Supplier complaint

HE-SC/2022/428

| Item name | IN CHAMBER KTM 512 DN15-20 | Mail | agnieszka.smeda@imi-hydronic.com |

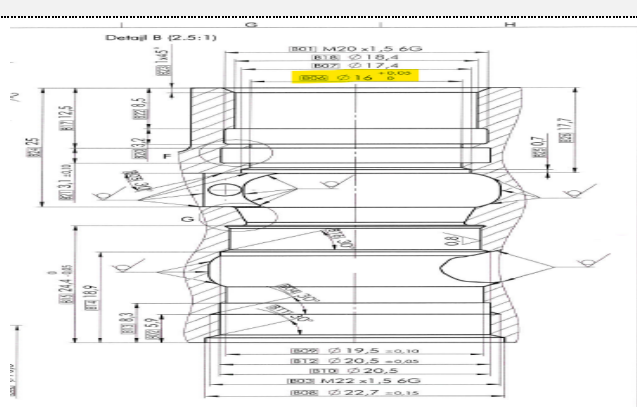
| During production we found 149 pcs item no. 14049M-EXT1 which we can't assembly. Diameter 16,00 is below tolerance - in attachment you can find measurement results. | | | |

- ☐ Released for production with derogation
☐ Released for rework / sorting at IMI
☐ Released for rework / sorting at Supplier
☒ Return to supplier / remove from stock

- ☒ 8D report
☒ Sorting at supplier site
☒ 100% Checked next delivery
